MILE POST 7 WEST RIDGE RAILROAD RELOCATION, DAM EXTENSIONS, AND STREAM  
MITIGATION PROJECT ENVIRONMENTAL ASSESSMENT WORKSHEET (EAW)

RECORD OF DECISION – FINDING OF FACT 28.i  
1975 WAHLER REPORT

Evaluation of  
**MILE POST 7 ON-LAND  
TAILINGS DISPOSAL PLAN**  
Proposed by Reserve Mining Company  
Performed by W.A. Wahler and Associates  
For the State of Minnesota

REVIEW OF  
RESERVE MINING COMPANY'S  
PRELIMINARY MILE POST 7 TAILINGS DISPOSAL PLAN  
SILVER BAY, MINNESOTA

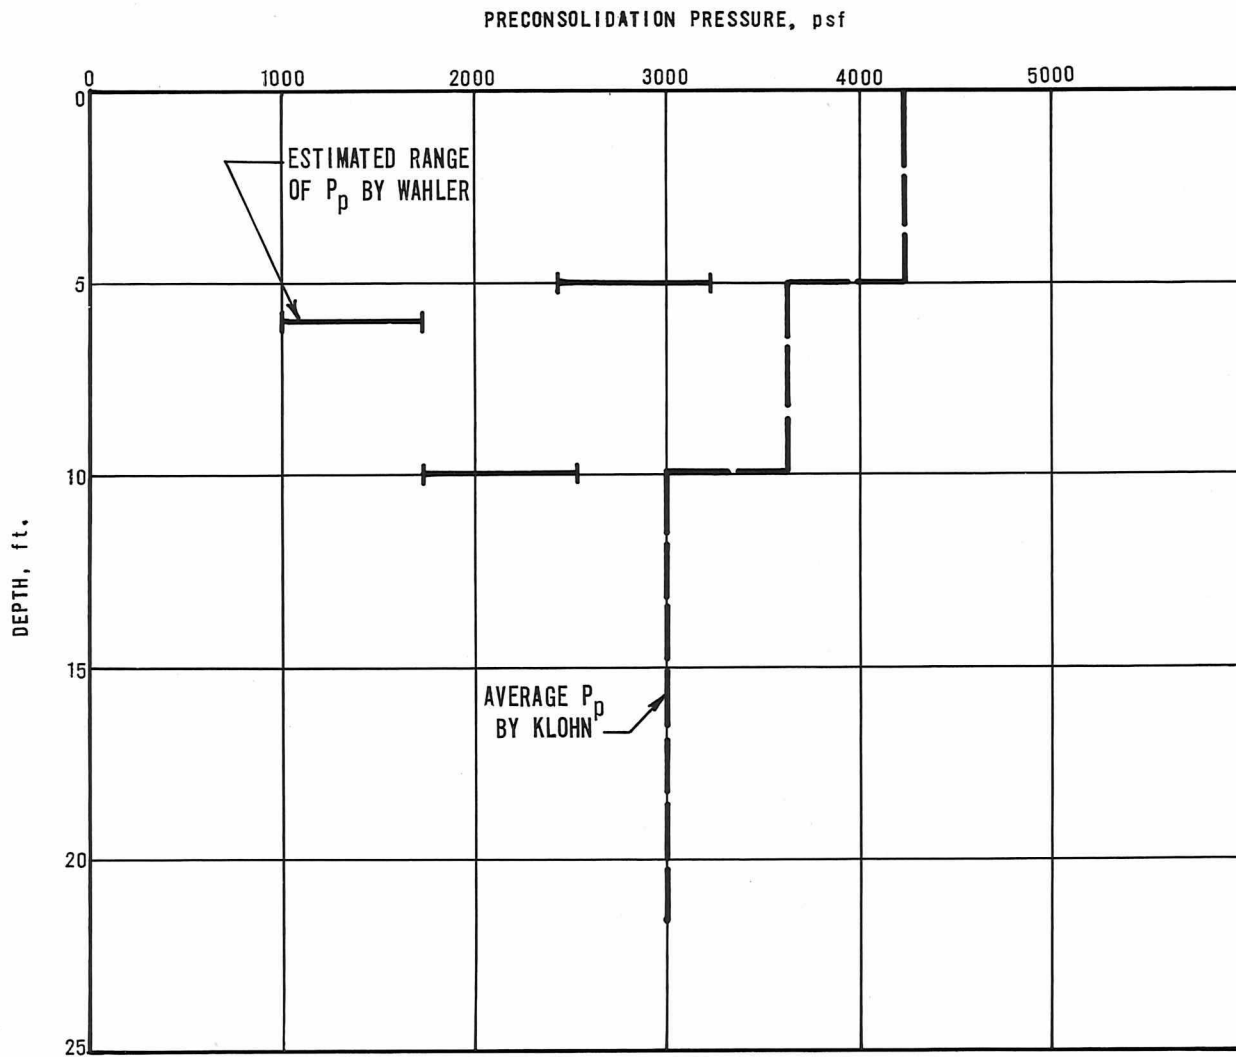
Maximum past pressure and compression indices are estimated from the results of oedometer tests. Three such tests were performed on the lacustrine clay in our laboratory, and the values of the preconsolidation pressure determined from those tests are plotted on Drawing III-8, superimposed over the design values presented in the Kohn Leonoff report. Large uncertainties are inherent in any estimate of preconsolidation pressure (uncertainties in this case created by the varved nature of the materials, the always unknown degree of sample disturbance and other factors) and, therefore, in our opinion, the differences between our values and those presented by Kohn Leonoff are well within this range of uncertainty.

Values of compression index ( $C_c$ ) and recompression index ( $C_r$ ) from the three tests are also summarized and compared to the values of Kohn Leonoff on Drawing III-8. These values are in reasonably good agreement.

111-9

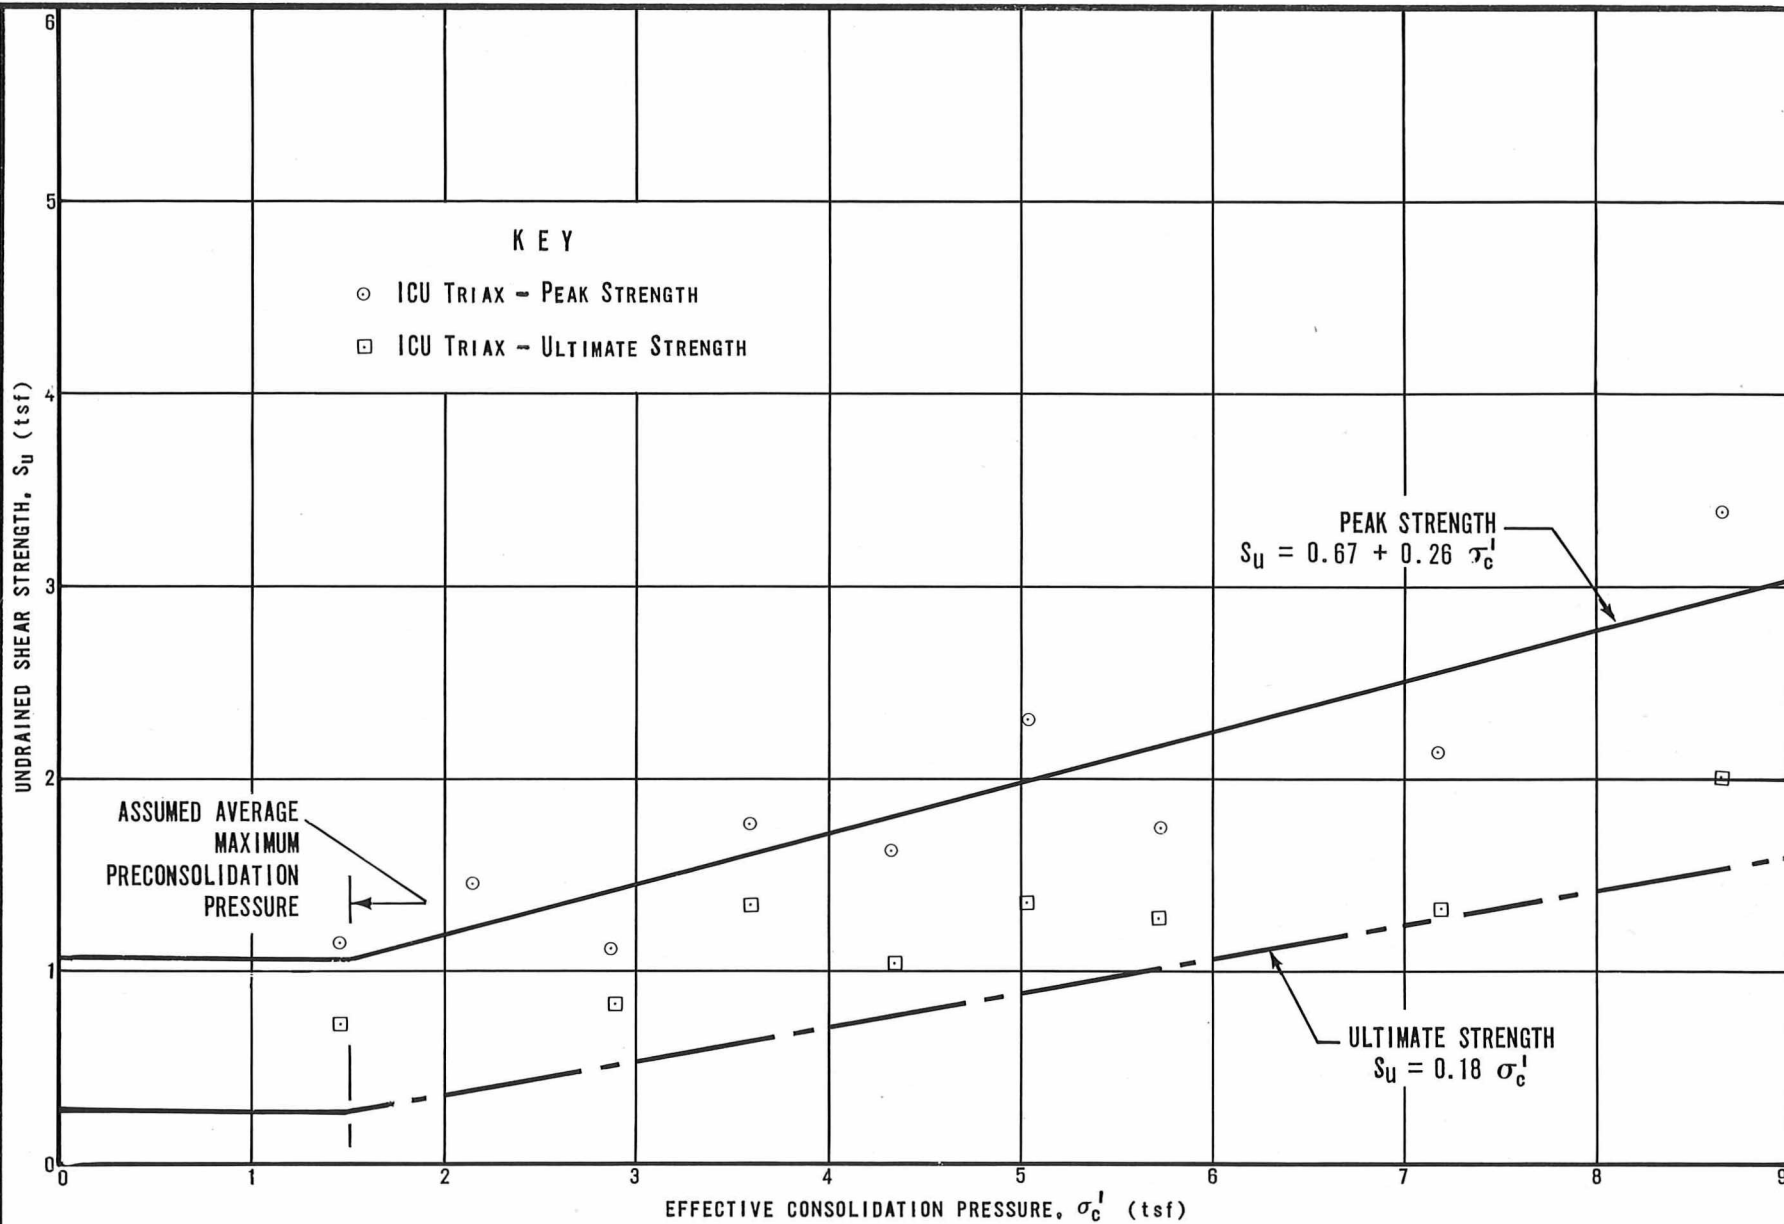
Estimates of the change in undrained shear strength that accompany changes in effective consolidation stress have been presented on Drawing III-9. This relationship, combined with consolidation theory (which provides the means by which to estimate the time-rate of consolidation) has been used to derive the relationships shown on Drawing III-11, which relates the average undrained shear strength of the foundation to construction schedule presented on Drawing 292-0026 of the design report.

Stability analyses of the starter dam have been carried out by Klohn Leonoff and the results presented on Drawing 292-0032 (Figures 2 and 3). As indicated earlier, we independently calculated the probable rates of consolidation and gain in shearing strength due to the sand drains, for comparison with values calculated by Klohn Leonoff. These calculations, and the conservative assumptions involved, are shown on Drawing III-11, indicating that the undrained strength parameters assumed by Klohn Leonoff for the stability analysis at completion of the starter dam are reasonably conservative. Klohn Leonoff, using undrained strength parameters (referred to as "total stress" analysis), computed factors of safety of 1.4 and 1.5, respectively, for both upstream and downstream slopes of the starter dam at the end of partial construction to Elevation 1150 and at the completion of construction to Elevation 1170. The range of common practice in earth dam design is to require minimum factors of safety during construction and prior to reservoir filling of up to about 1.3, depending upon the level of uncertainty and the risks involved. On that basis, it appears that the factors of safety calculated for the starter dam at the completion of construction to Elevation 1170 are within acceptable limits. As discussed in Section C of this chapter, we do recommend that the strength data utilized in stability analyses, for the case of partial completion to Elevation 1150, be re-examined.

Stability analyses have been carried out by Klohn Leonoff and the results presented on Drawing 292-0032 (Figures 4, 5, and 6). Reference is again made to our conservative calculations of shear strength as a function of time shown on Drawing III-11 which indicate that the undrained strength parameters assumed by Klohn Leonoff for stability analysis of the ultimate dam are reasonably conservative. Based upon the Klohn Leonoff analysis using undrained strength parameters (referred to as "total stress" analysis), factors of safety of 1.6 and 1.4, respectively, were computed for the upstream and downstream slopes of the completed dam with an assumed tailings pond level of 1182 feet. It is fairly common practice in earth dam design to require minimum factors of safety of 1.5 or greater for full reservoir nonseismic conditions, again depending upon the level of uncertainty and the risks involved. Judged against this criterion, the factor of safety calculated for the upstream slope appears to be acceptable. The computed factor of safety for the downstream slope appears to us to be reasonably acceptable even though it is somewhat lower than 1.5. The tailings pond level at the completion of construction is almost 100 feet lower than the dam crest and, with the considerably lesser risk involved, it appears to us justifiable to accept computed factors of safety between that for end-of-construction conditions (normally required minimum factor of safety of 1.3) and full reservoir conditions (normally required minimum factor of safety 1.5). As the tailings pond level rises, the factor of safety could also be expected to increase (due to continued consolidation of the downstream foundation and increased shear strength resulting therefrom), such that it would appear that a factor of safety of 1.5 could probably be calculated for the undrained strengths developed at a point in time about 3 years following completion of the dam. We recommend, however, that the final design analyses address the relationships between tailings pond level, configurations of critical failure surfaces, and factors of safety.

111-10

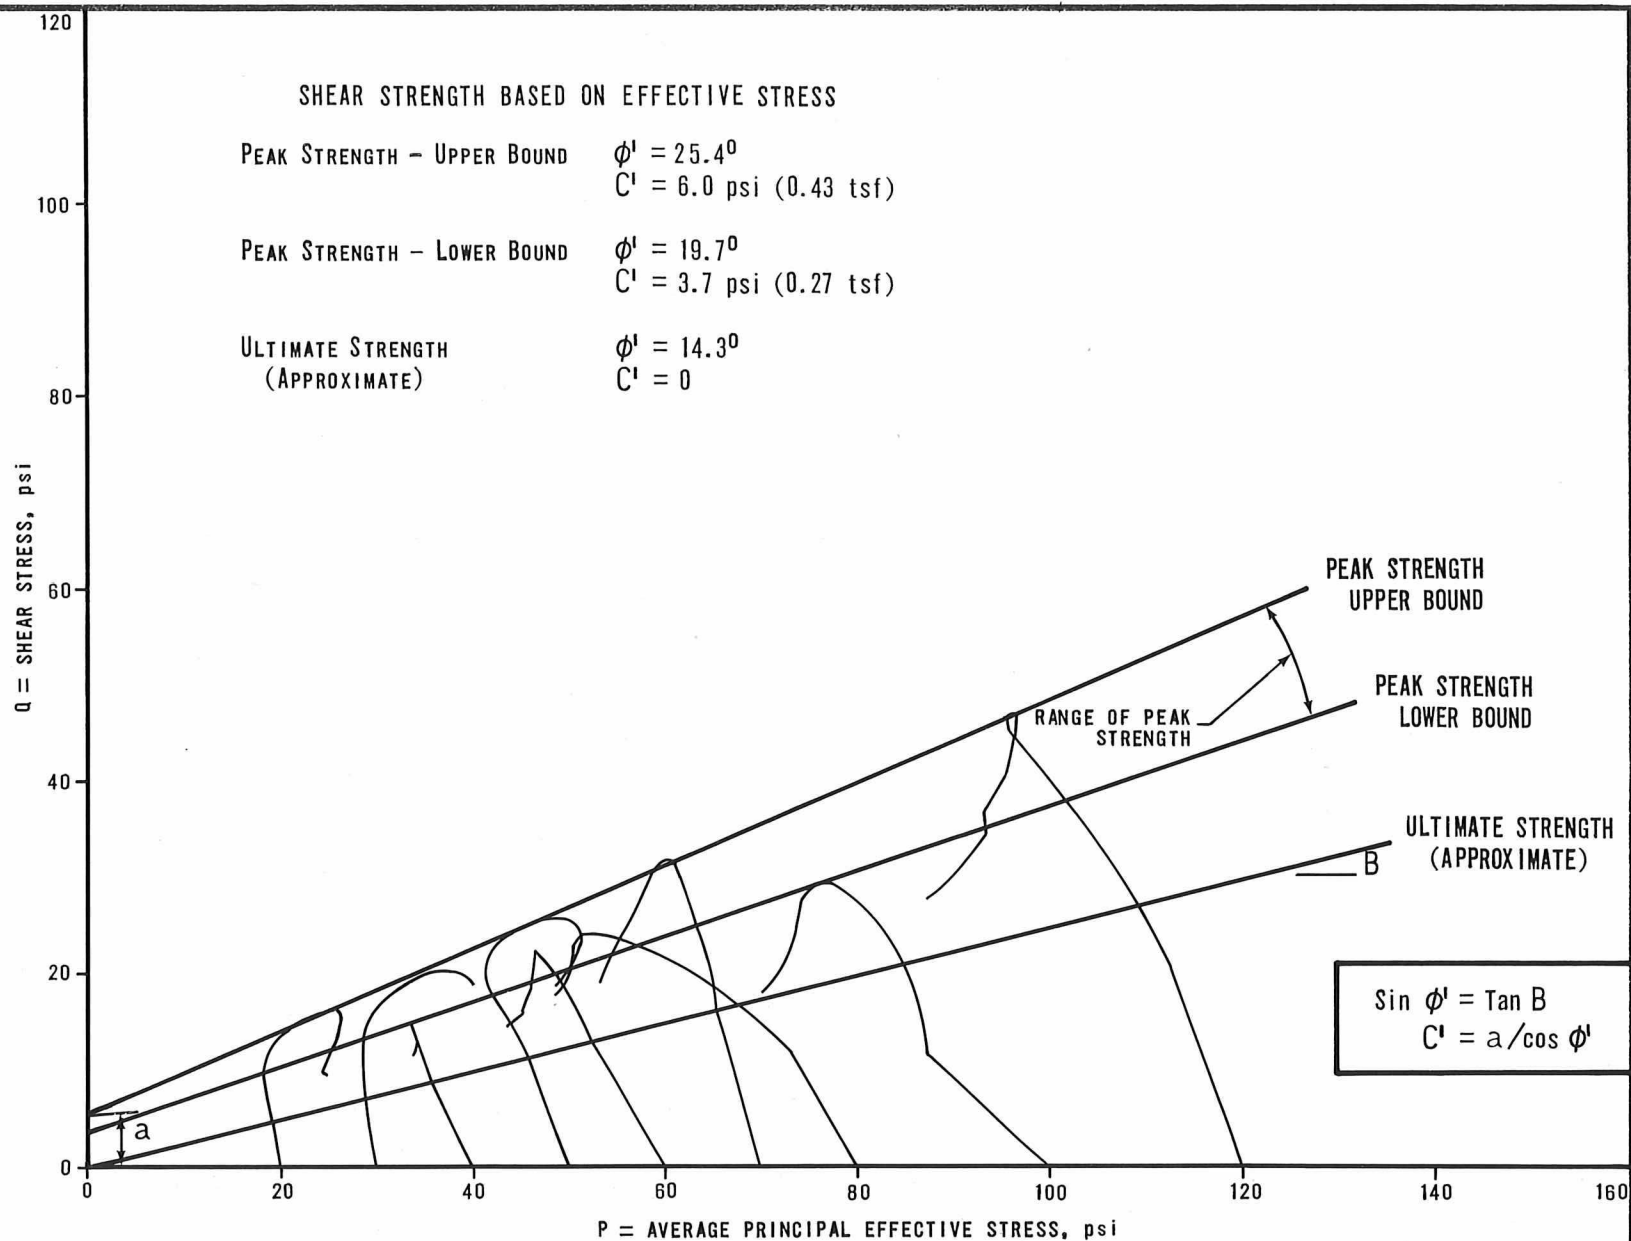
h. Effective Stress-Strength Parameters - Stability analyses performed in terms of effective stresses to approximate long-term stability, require knowledge of the Mohr-Coulomb failure envelope, which is usually expressed in terms of the effective friction angle  $\phi'$ , and the unit cohesion  $c'$ .

These parameters can be obtained by plotting the results of our ICU tests in an alternate form as summarized on Drawing III-10. The resulting effective strength parameters obtained from our testing program are compared with design values proposed by Klohn Leonoff in Table III-4, below.
